Section 16 Planning Application for Temporary Open Storage of Freezer Vehicles, Air-conditioned Compartments and Spare Parts of Cooling Machinery Components for Vehicles for Sale, and Installation and Maintenance Workshop for Freezer Vehicles for a Period of 3 Years at Lots 401(Part), 404(Part), 405 RP(Part), 406 RP, 408 RP(Part), 409 and 410(Part) in D.D. 106, Pat Heung, Yuen Long, New Territories

Department	Date	Comments	Responses to Departmental Comments
Lands Department (LandsD)	19.4.2023	LandsD has grave concerns given that there are unauthorized building works and/or uses on Lot Nos. 405 RP, 406 RP, 408 RP, 409 and 410 all in D.D. 106 which area already subject to lease enforcement actions according to case priority. The lot owner(s) should remedy the lease breaches as demanded by LandsD.	Noted. The lot owner is currently remedying the lease breaches as demanded by LandsD and will submit relevant application to LandsD for consideration once the current application is approved.

Department	Date	Comments	Responses to Departmental Comments
Drainage Services Department (DSD)	25.4.2023	<p>(i) As the application site occupies the frontage of the nullah, overland flow from adjacent

Revised Fire Service Installations Proposal

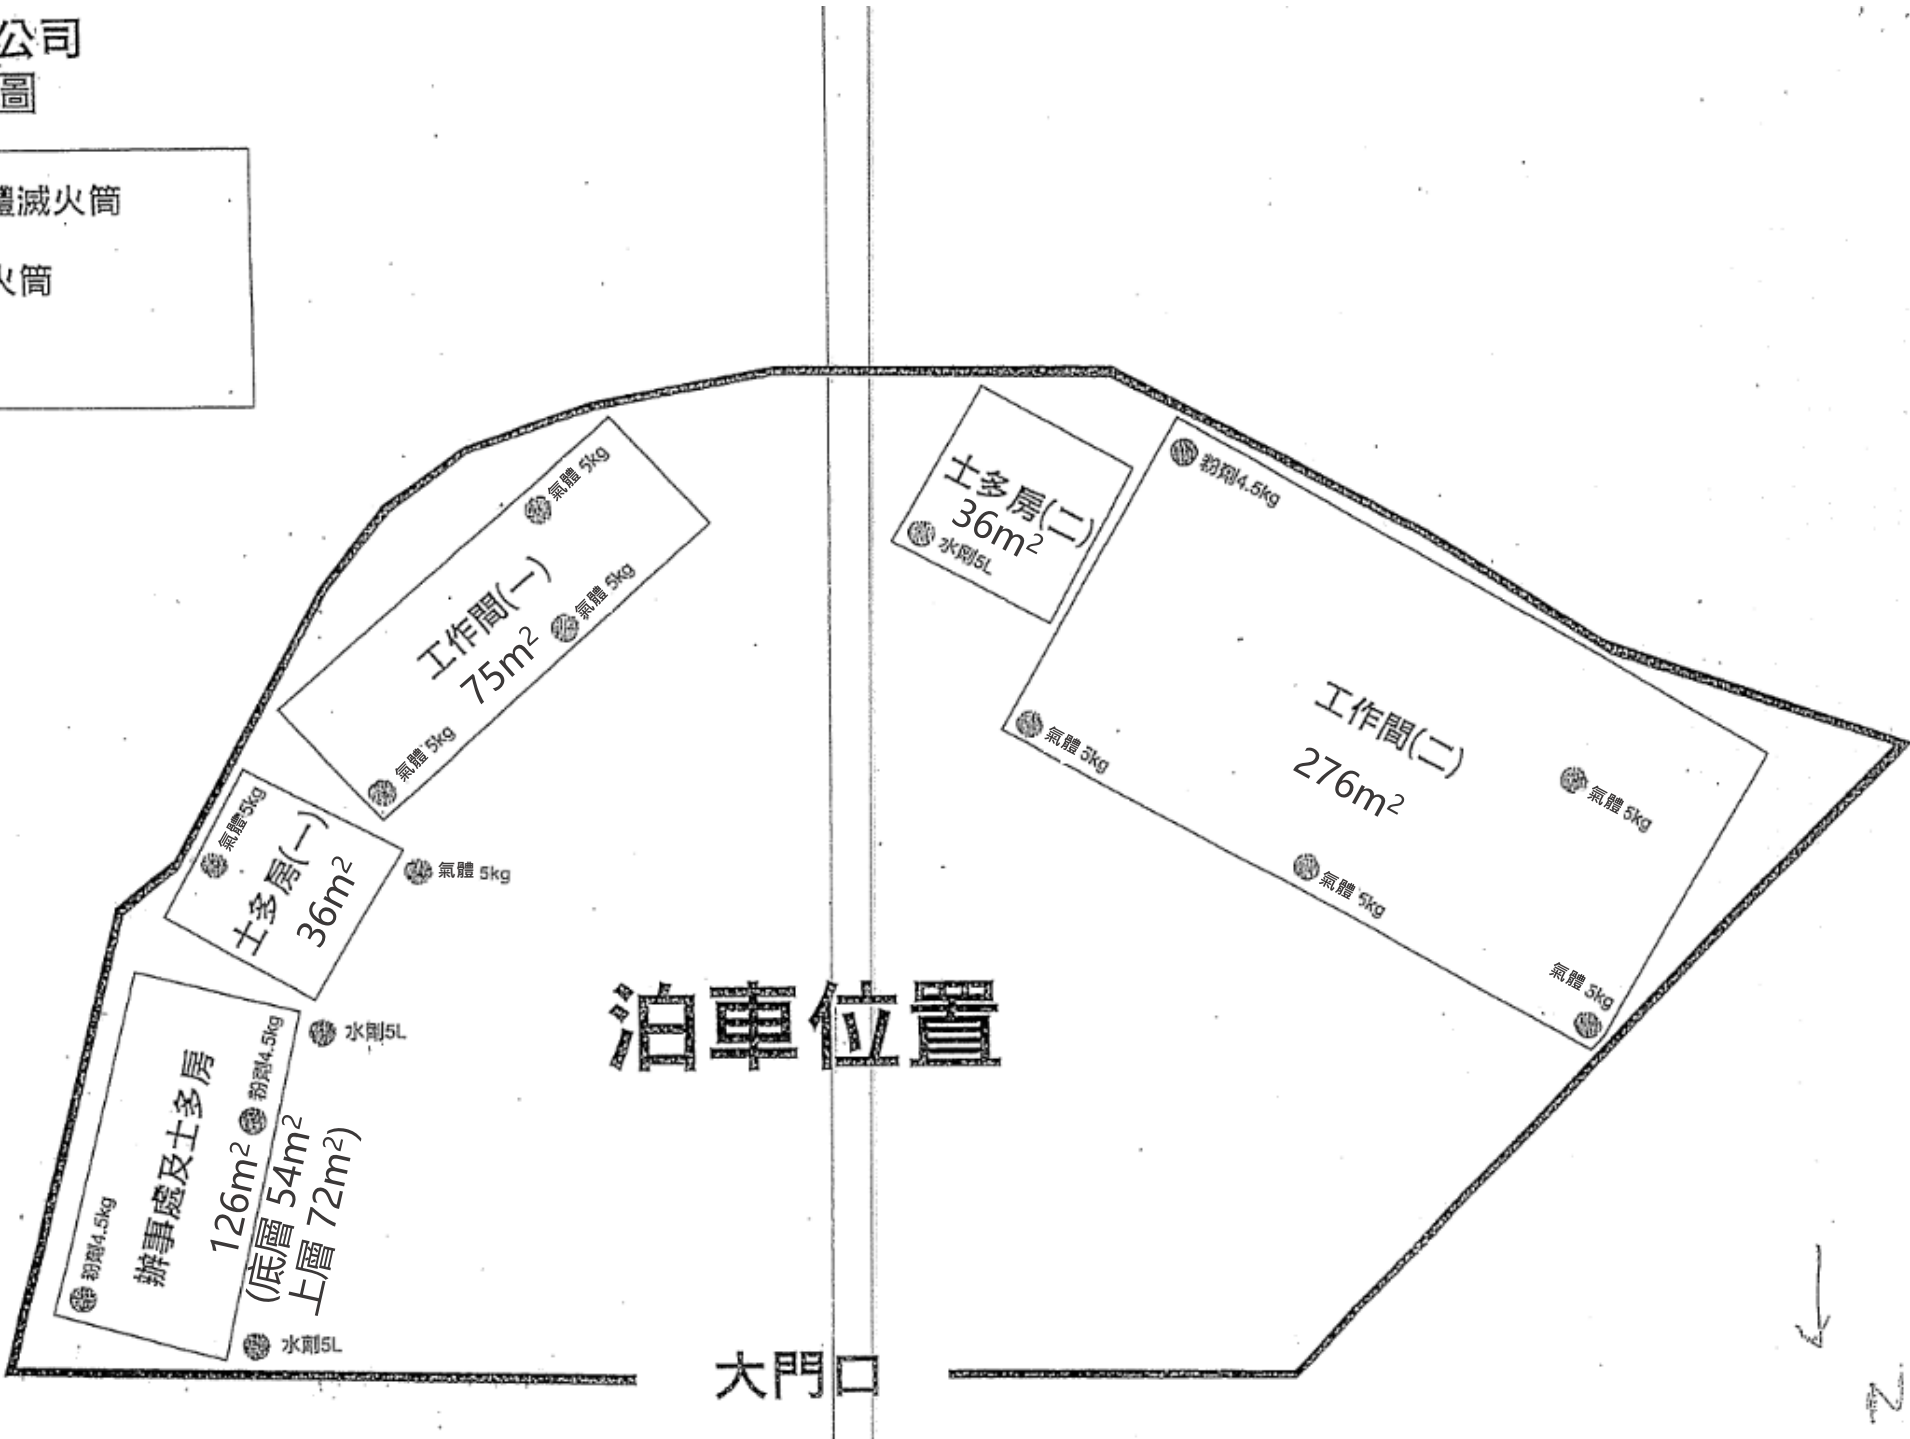
Department	Date	Comments	Responses to Departmental Comments
Fire Services Department (FSD)	26.4.2023	(i) Total floor area of each structure shall be clearly indicated on the plan; and (ii) Typo “汽體” shall be rectified.	(iii) Noted. Please find the revised fire service installations proposal at Appendix IV for your review. (iv) Noted and rectified.
